**NUCLEAR GENERATION GROUP
ANALYSIS / CALCULATION**

S10-0049
(Calculation #)

Auxiliary Building Overhead Crane (FHCR-5) Supporting Steel Structure – ANSYS Model
(Title including structures, systems, components)

Figure 2. Crane Boundary Conditions in Accordance with ASME NOG-1 (Ref. 3.4)

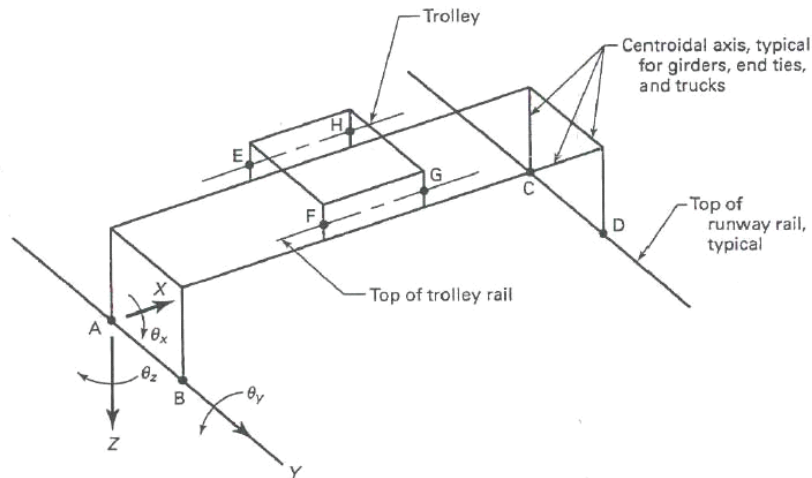
Lead Reviewer	(print/sign)	Discipline	Date
Item No.	Deficiency	Resolution	
1)	In all ANSYS models, change the CE's which define the relative movement between the trolley and the bridge to match those supplied by the crane-vendor.	The comments have been incorporated.
